**NOS. 94 – 98 GEORGE STREET, HORNSBY
DEVELOPMENT APPLICATION NO. 213/2015**

In response to your email correspondence, various discussions and our most recent meeting with both Council and SJB Planning representatives on 17 May 2016, please see below an address to your concerns as an accompaniment to modified architectural plans submitted under separate cover.

Figure 2: Design resolution at the boundary interface.

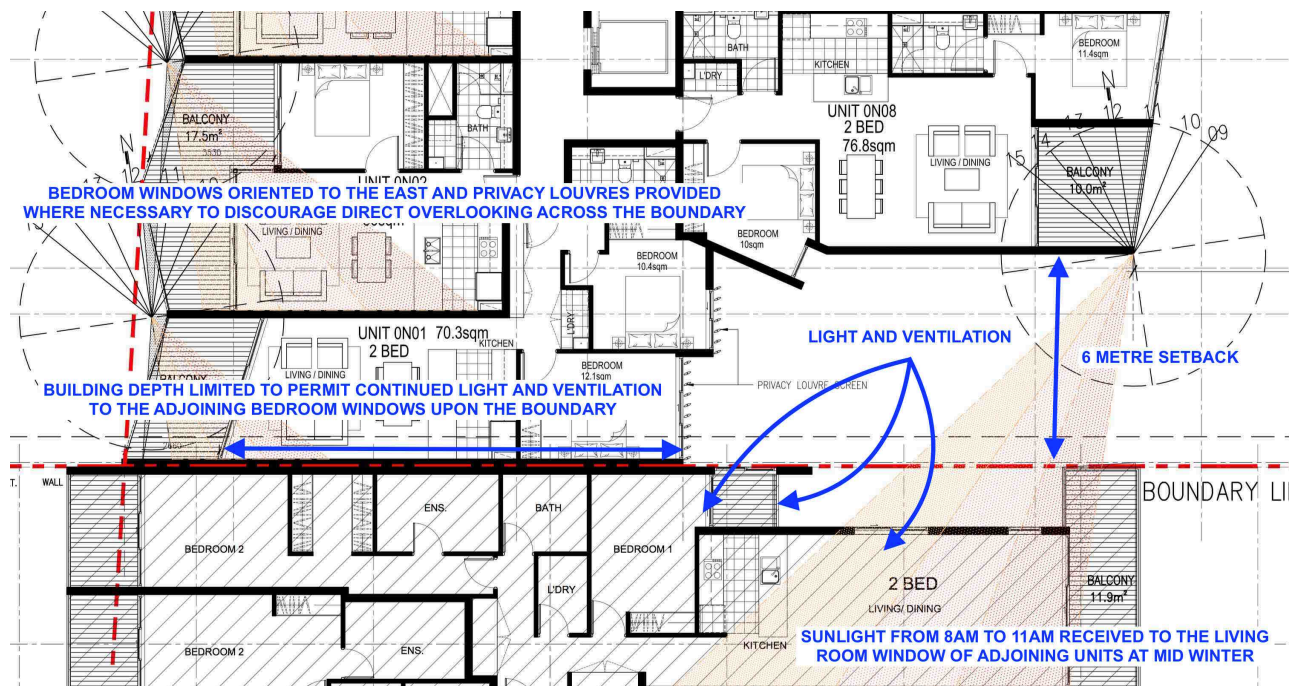
The proposed development does not comply with building separation requirements along the northern boundary. Adequate justification has not been provided detailing how visual and acoustic privacy is to be maintained between the proposed building and a future building at Nos. 100-106 George Street.

Adequate building separation has not been provided from neighbouring building to the south and for a future building to the north.

The interface between the existing development at No. 90 George Street and the proposed development has been carefully considered in design modifications to ensure fenestration does not preclude light, ventilation or outlook to either of the buildings.

Whilst acknowledged that the adjoining development at No. 90 George Street 'borrows amenity' via a north facing balcony openings located upon the common boundary that permit light and ventilation to bedroom windows, the proposed development continues to permit light and ventilation to these openings, and the typical bedroom window beyond (see **Figure 1** above and **Figure 2** over page).

The proposed development limits the depth of the floorplate, 'glass line to glass line', to approximately 12.5 metres adjacent the common boundary; provides a separation of 6 metres to the adjacent boundary beyond this footprint; and ensures that windows are oriented to the east and also provided with privacy louvres to avoid direct conflict to the south across the common boundary.

Solar access diagrams provided by Tony Owen Partners further demonstrate the modified design is able to accommodate a minimum 2 hours of sunlight to the living room windows and private open space of the adjoining units at No. 90 George Street at mid winter (see extract diagram at **Figure 2** over page).

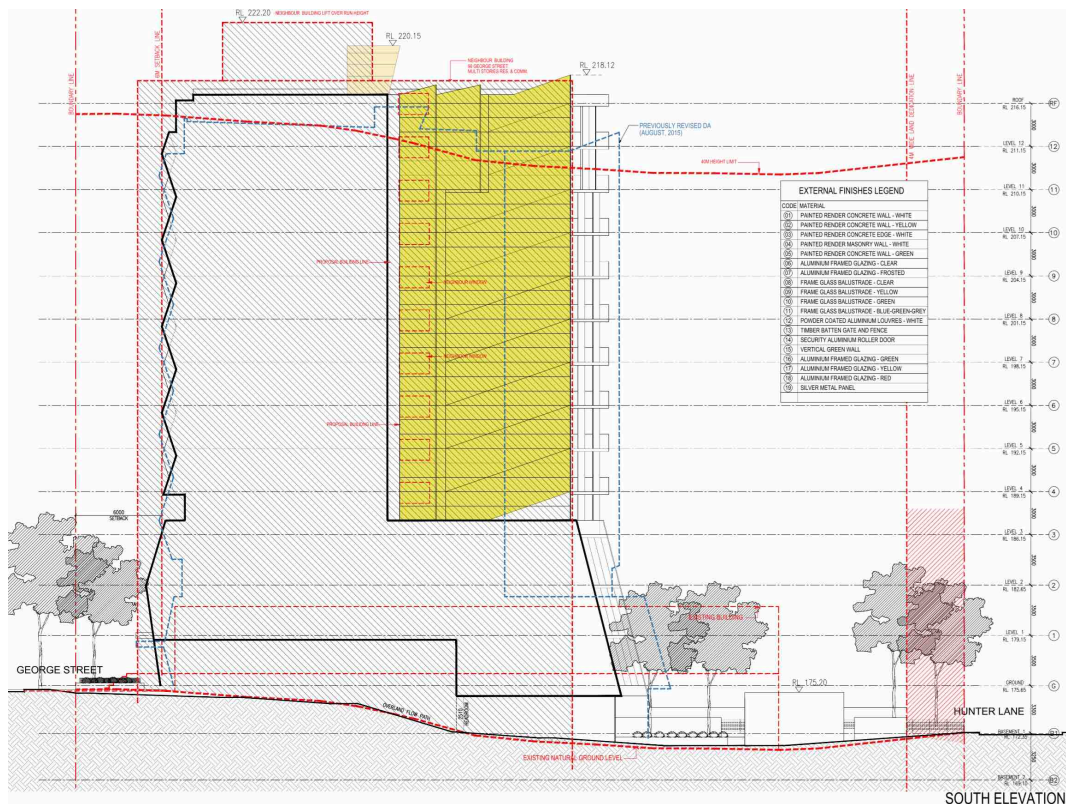
The revised plans indicate that the lift overrun and a rear section of the top floor of the building would exceed the maximum height limit.

The highest point of the building is the lift overrun servicing the rooftop communal open space. At RL 220.45, the maximum height of the building is determined to be 48.855 metres, a point variation of approximately 22%.

It is noted the proposed development is marginally smaller than its southern neighbour, the Avanti development at No. 90 George Street, which is also thirteen (13) storeys in height. The lift overrun of the Avanti development is 1.75 metres higher than the lift overrun proposed, and the upper level of their balustrade 0.58 metres higher than the topmost balustrade of the communal open space area proposed (see **Figures 1 & 2** over page).

The lift overrun and upper level balustrade height breach is the result of the applicant wishing to provide an alternative rooftop communal open space and wheelchair access thereto, affording greater amenity than that provided at the ground floor level adjacent the Hunter Lane frontage.
